Nomad

SERVICE BULLETIN

Reference No 168

SUBJECT: FITMENT OF IMPROVED NOSEWHEEL FORK
(MOD N412)

Rework of Nose Gear Oleo Plunger Figure 1

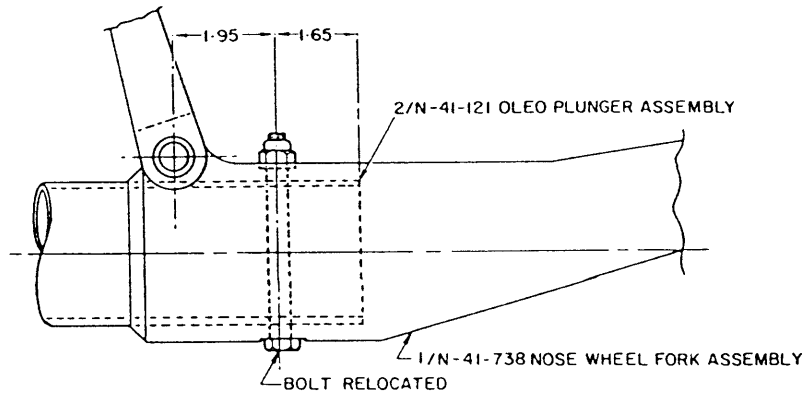
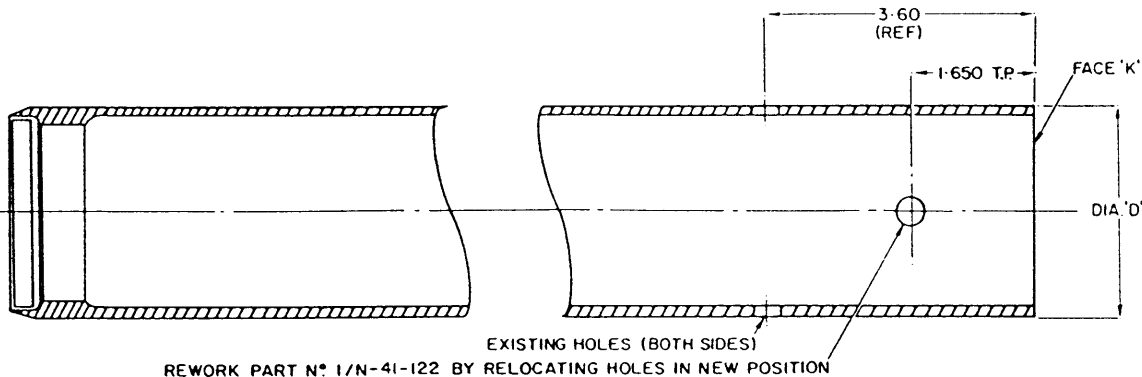
Pre-mod N412 - The nosewheel fork attachment bolt is located on the forging flash line and this has resulted in some instances of crack development in service. Post Mod N412 replacement nosewheel forks have the attachment bolt relocated to a more favourable position but this requires rework of the nose oleo plunger in order to fit the modified fork.

The existing nosewheel fork is replaced by one with the attachment bolt relocated to a lower position in the attachment collar and with the bolt axis aligned fore and aft. The nosewheel oleo plunger is reworked to suit.

- A. Jack up the aircraft (Ref MM 7-00-00).
- B. Remove nosewheel from nose gear oleo leg (Ref MM 32-40-61).
- C. Remove the nose gear oleo leg (Ref MM 32-20-11).
- D. Remove the existing nosewheel attachment fork from the nose gear oleo leg (Ref Type N-41-620, CMM 32-01-02).
- E. Rework the oleo plunger as shown on Figure 1.

(5) The axis of the new holes should be drilled at right angles to the axis of the existing holes, within the positional tolerance stated. After pilot drilling, the holes should be reamed or bored to final size.

CAUTION: CARE SHOULD BE TAKEN TO DRILL THE HOLES WITHIN THE STATED POSITIONAL TOLERANCE SINCE IT IS IMPORTANT THAT VERTICAL LANDING LOADS BE TAKEN BY DIRECT CONTACT BETWEEN THE PLUNGER END AND THE BOTTOM OF THE SOCKET IN THE FORK, NOT BY THE ATTACHMENT BOLT.

REMOVE CHROME PLATING LOCALLY, 0.25 DIA. MAX., TO PROVIDE PILOT DRILL ACCESS. (REFER PARA 2E(4)).

DRILL AND REAM 0.3776 DIA. RIGHT THROUGH BOTH SIDES. POSITIONAL TOLERANCE 0.002 DIA. DATUM DIA. 'D' FACE 'K'.
0.3770

EXISTING HOLES ACCEPTABLE.

THIS DRAWING SHOWS THE METHOD FOR REWORKING THE DETAIL PART N° 1/N-41-122. EXISTING PLUNGER ASSEMBLIES, PART N° 1/N-41-121 CAN BE REWORKED SIMILARLY WITHOUT DISASSEMBLY.

AFTER REWORK, PLUNGER DETAIL PART N° 1/N-41-122 BECOMES PART N° 2/N-41-122 AND PLUNGER ASSEMBLY, PART N° 1/N-41-121 BECOMES PART N° 2/N-41-121.
